WAYZATA PLANNING COMMISSION

City of Wayzata Planning Commission Agenda Report

MEETING DATE: March 18, 2019	AGENDA ITEM: 4.b.
TITLE: Adoption of Report and Recommendation of Approval of Design Review for Chase Bank at 1022 Wayzata Blvd E	
PREPARED BY: Jeff Thomson, Director of Planning and Building	
REVIEWED BY: N/A	
60 DAY DEADLINE: May 2, 2019

REPORT AND RECOMMENDATION OF APPROVAL OF PROJECT DESIGN AT 1022 WAYZATA BLVD

SHEET TITLE
LIGHTING PLAN

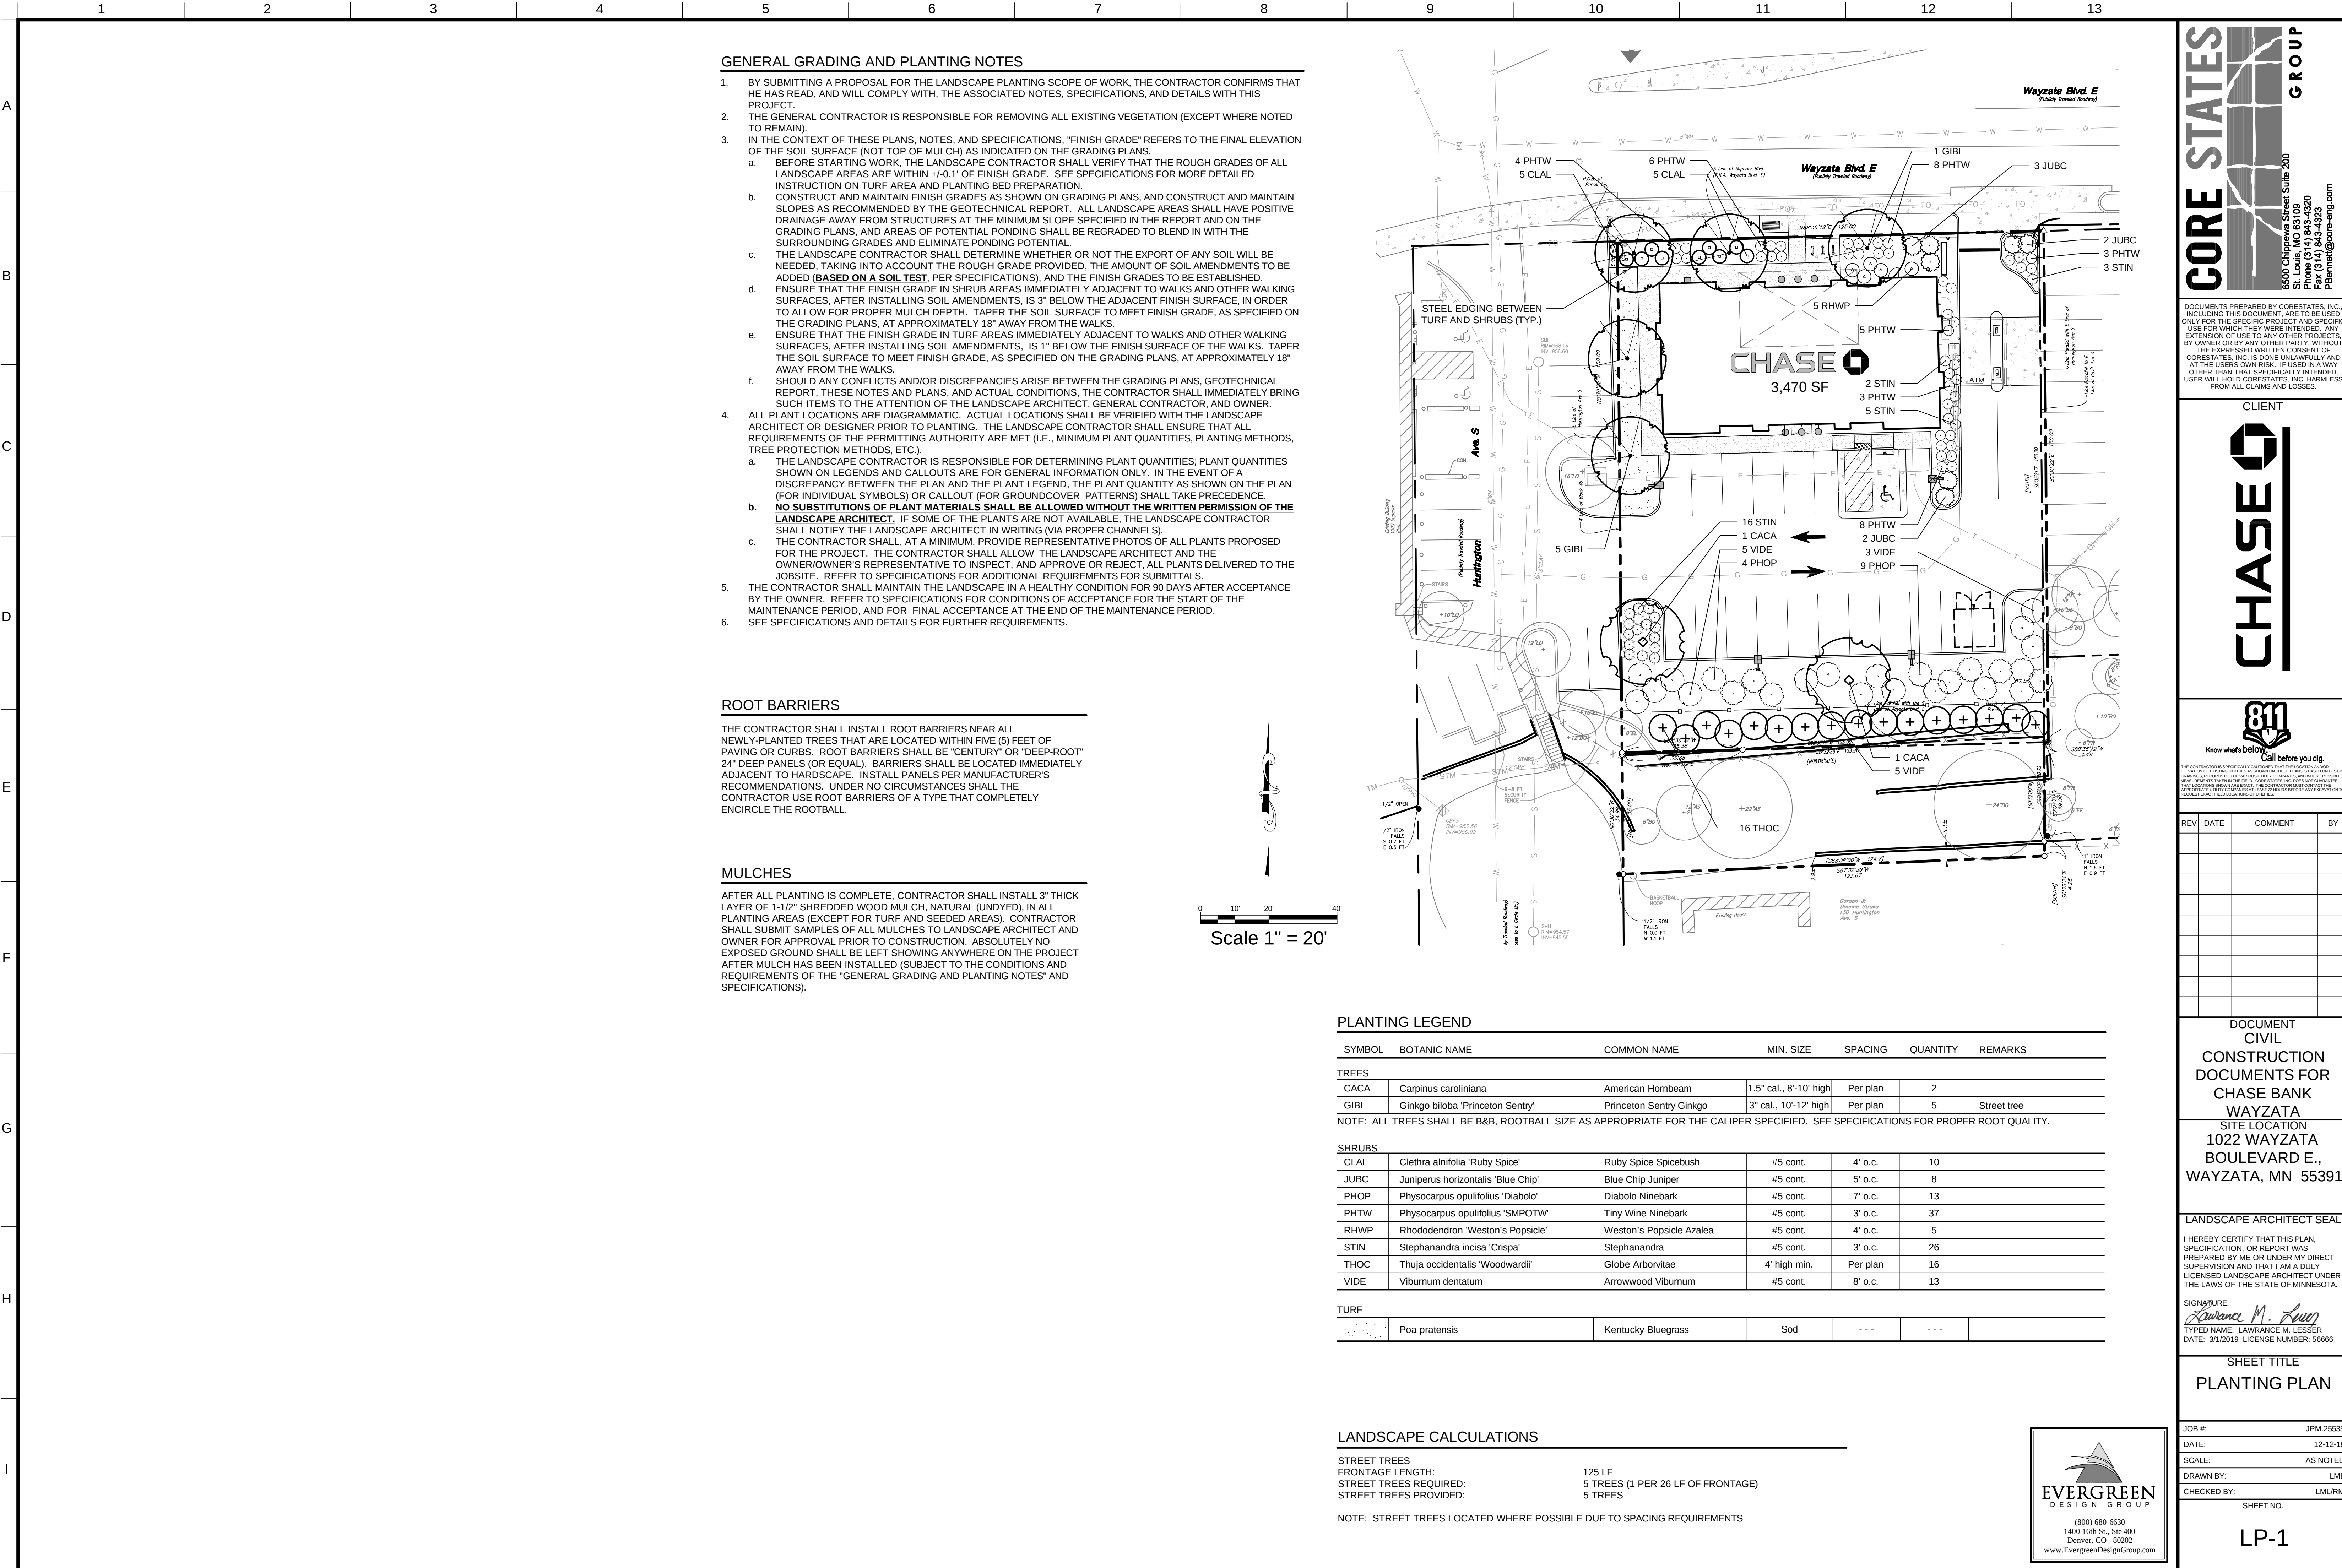
42
43 Commissioner Bashium stated that she is having difficulty with the application. She
44 acknowledged that the illumination of the light poles at the property line is zero, but she questioned
45 what it would be on at neighbor's deck height. She questioned if a six-foot tall fence would be

29
30 Commissioner Merriam stated that she would like to see the two light posts at the southern end of
31 the parking lot lowered by at least five feet, and if that means they have to add a light post that is
32 acceptable.

- 1. The globe arborvitae trees along the south side of the parking lot must be a minimum of 6 feet in height.
 - 2. Additional globe arborvitae trees with a minimum height of 6 feet, or other evergreen trees acceptable to the City, must be planted along the south east corner of the parking lot to provide screening to the adjacent residential properties.

SOUTH ELEVATION SCALE: 1/16"=1'-0"

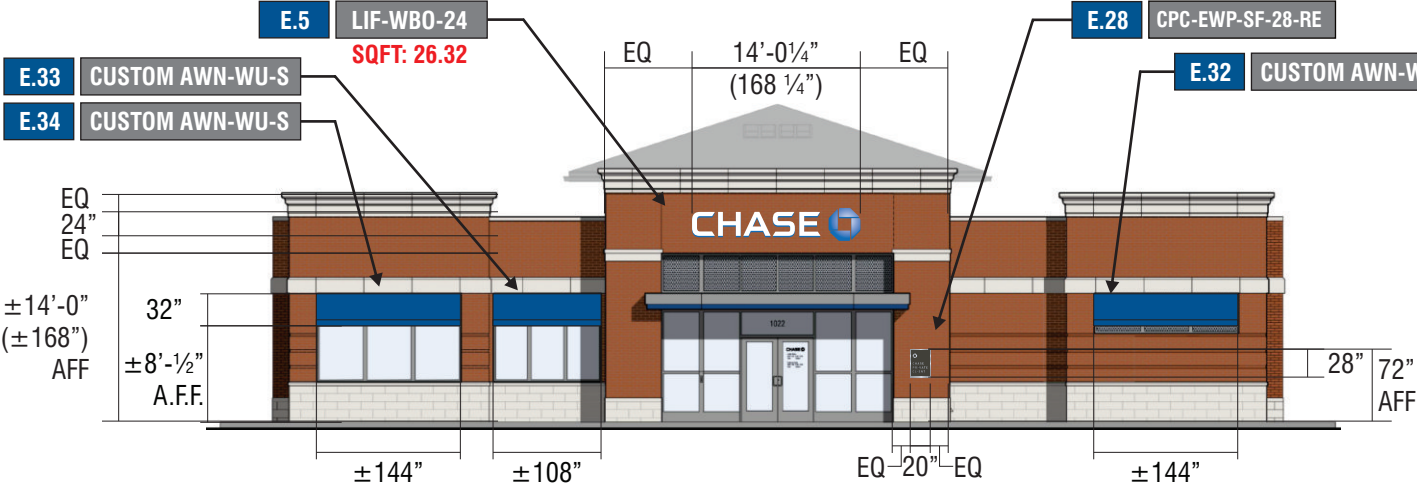
4
5 Commissioner Merriam asked about the illuminated sign on the south side of the building. She
6 added that the Comprehensive plan states that the City is to develop and enforce ordinances to
7 eliminate the visual pollution created by signs and franchise architecture. She stated that the
8 illuminated signage on the southern side of the building faces residential properties and should be
9 considered visual pollution.

15
16 Commissioner Douglas stated that she does not think that the illuminated sign on the south side of
17 the building is compatible with the location.

1 Commissioner Iverson stated that she would like to have the southern sign completely eliminated
2 because it faces a neighborhood.

Commissioner Parkhill withdrew his previous motion and made a new motion, seconded by Commissioner Merriam, to direct staff to prepare a draft Planning Commission Report and Recommendation, with appropriate findings, reflecting a recommendation of approval of the project design and the requested design deviation for the façade transparency on the front of the building for Chase Bank at 1022 Wayzata Blvd East, for review and adoption at the next Planning Commission meeting, with the conditions that the south facing sign not be illuminated between the hours of 10p.m. and 8a.m., and with a request that Chase consider lowering the southern light posts and planting 10 foot high trees at the fence line. The motion carried 6 ayes and 1 nay (Iverson).
